Illinois Department of Transportation

SUBJECT: Chicago Executive Airport
Wheeling/Prospect Heights, Illinois
Cook County
Illinois Project Number: PWK-5161
SBG Project Number: 3-17-SBGP-TBD
Contract No. PA067
Item No. 05A, June 13, 2025 Letting
Addendum A

NOTICE TO PROSPECTIVE BIDDERS

To revise plans, special provisions, and schedule of prices.

INDEX TO SHEETS, SUMMARY OF QUANTITIES
AND GENERAL NOTES

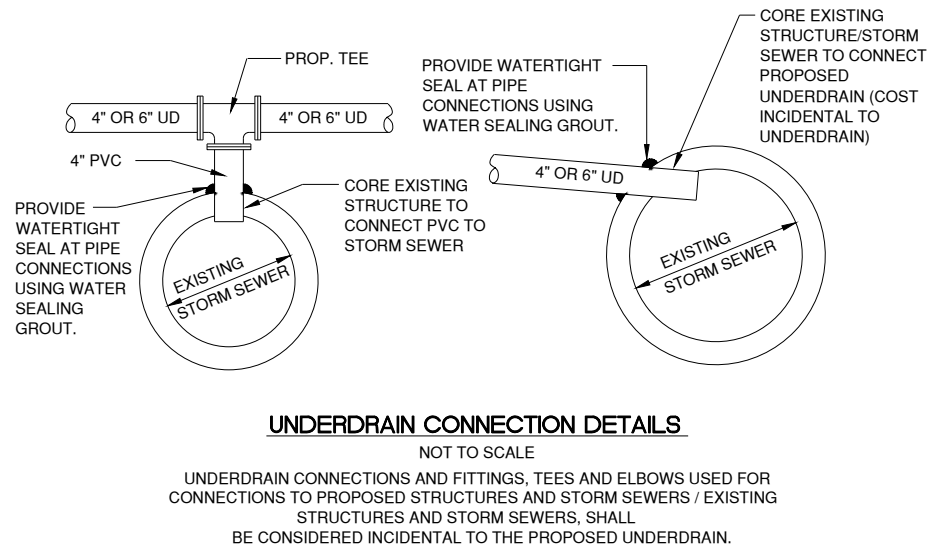
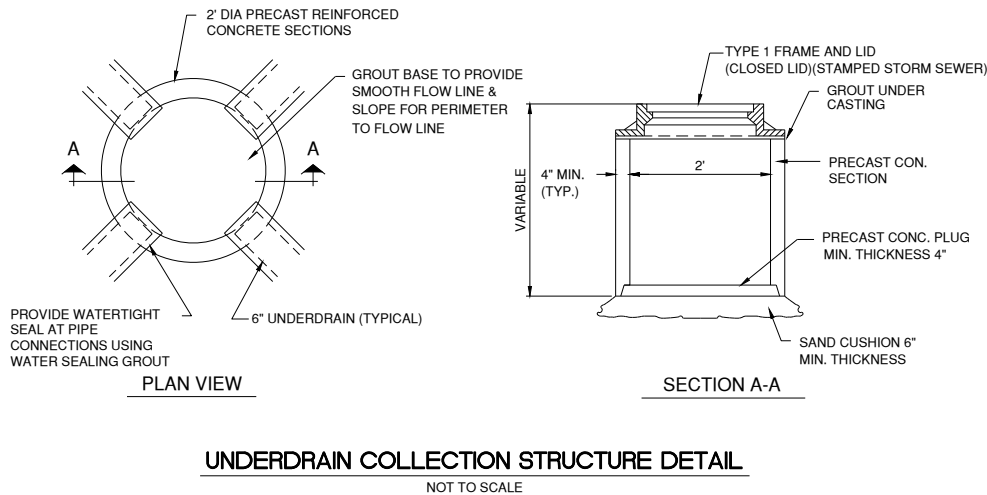
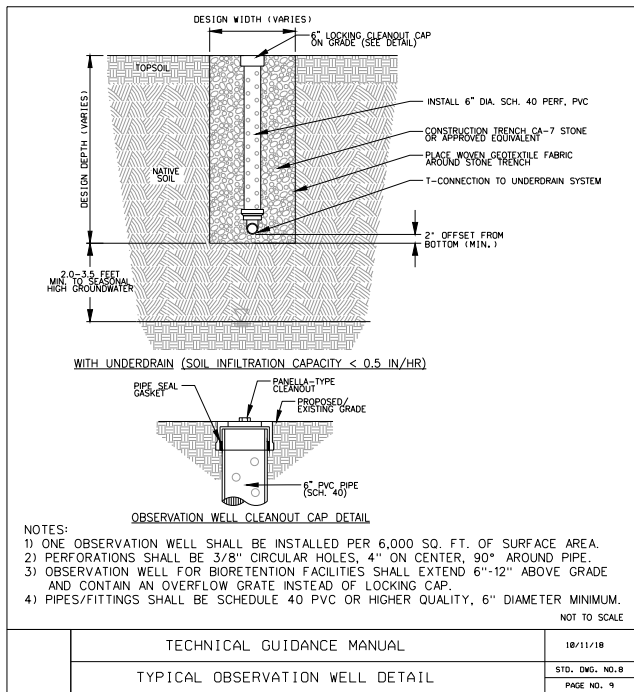
1. Sheet 2 – Index to Sheets, Summary of Quantities and General Notes
 - a. Summary of Quantities table, Delete Item AR800004 Restrictor Plate – 1 Each; Revised AR705504 4" Perforated Underdrain – 80 Foot, AR705506 6" Perforated Underdrain – 1,205 Foot, Item AR705544 4" Non Perforated Underdrain – 45 Foot, and Add Item AR705546 6" Non Perforated Underdrain – 201 Foot

DRAINAGE AND MISCELLANEOUS DETAILS - 3

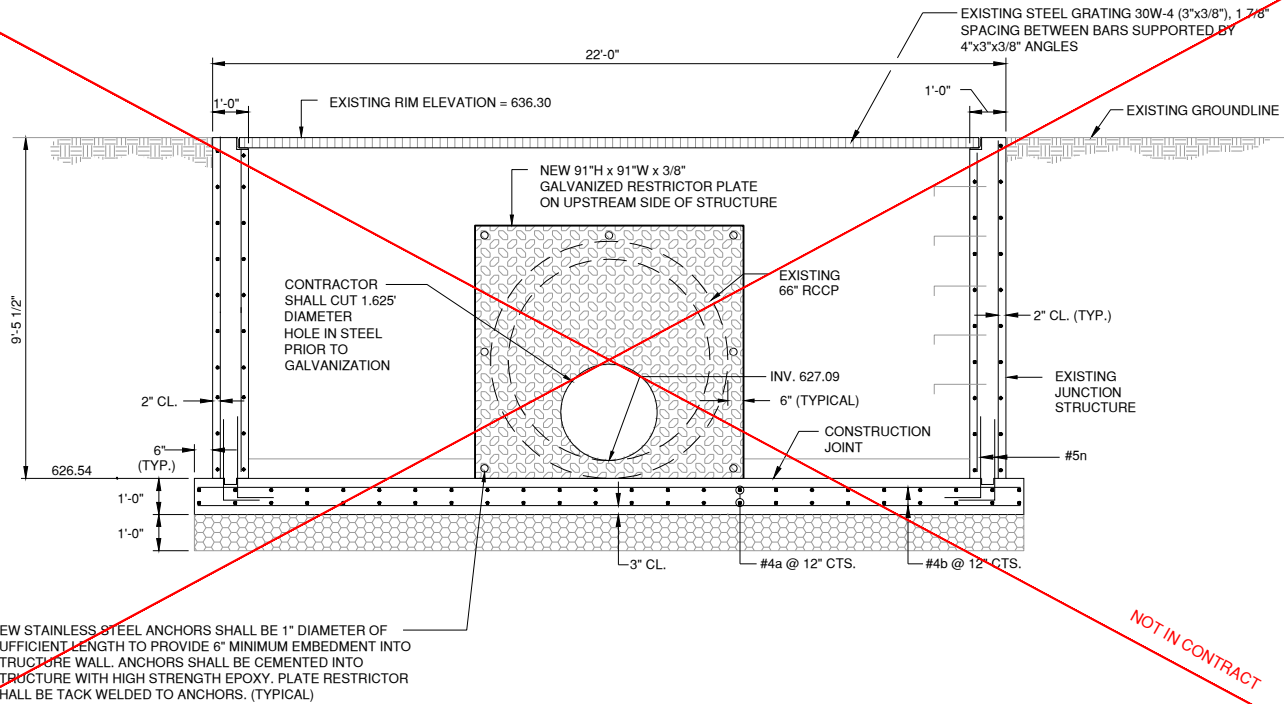
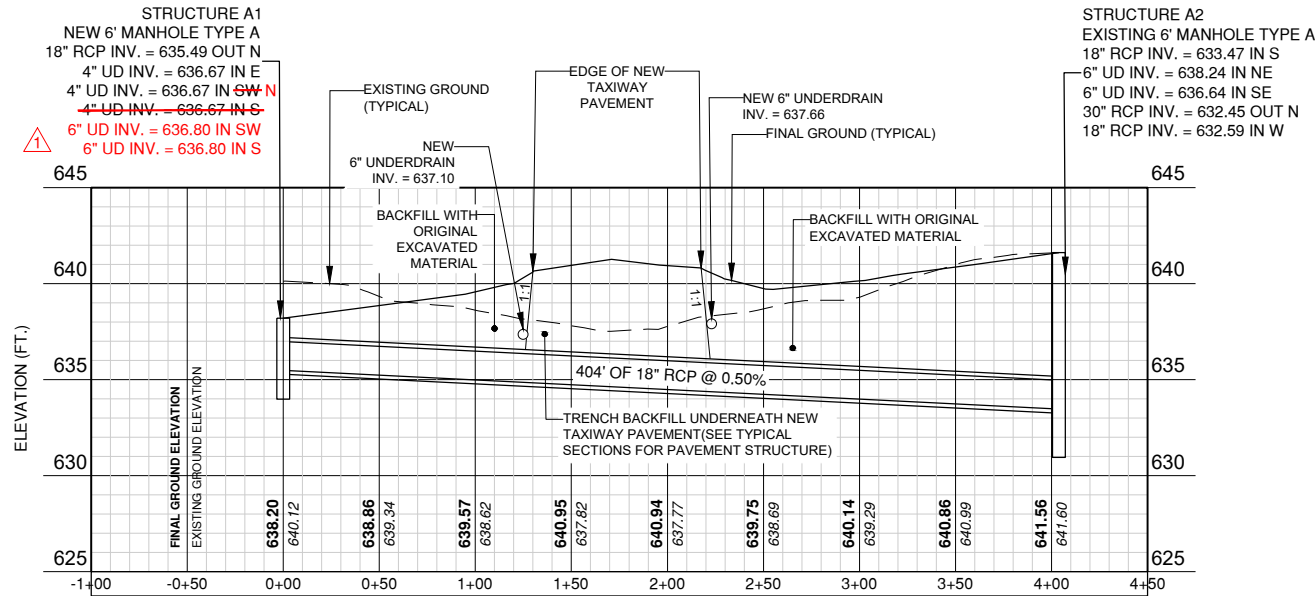
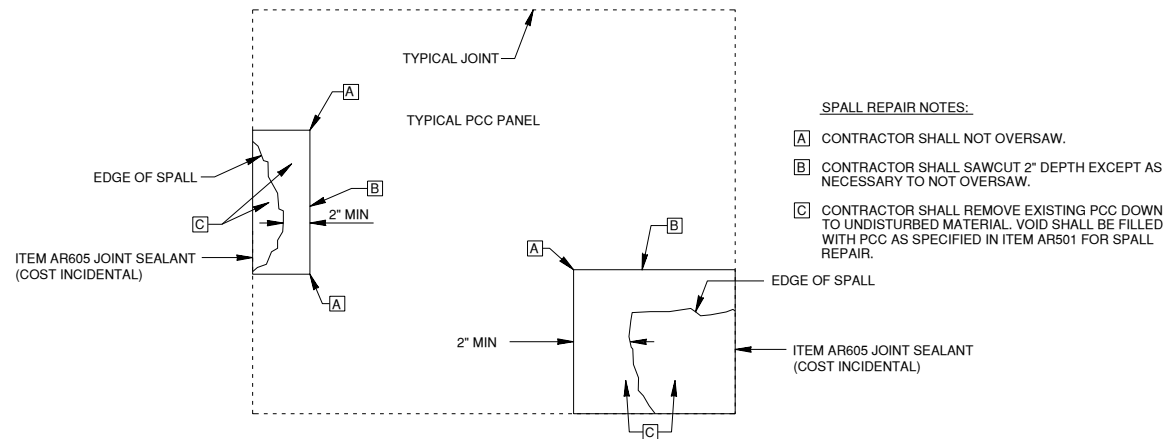
5. Sheet 26 – Replace Drainage and Miscellaneous Details – 3 with Revised Drainage and Miscellaneous Details – 3
 - a. Revised and added underdrain inverts in storm sewer profile

- b. Delete Install Restrictor Plate detail
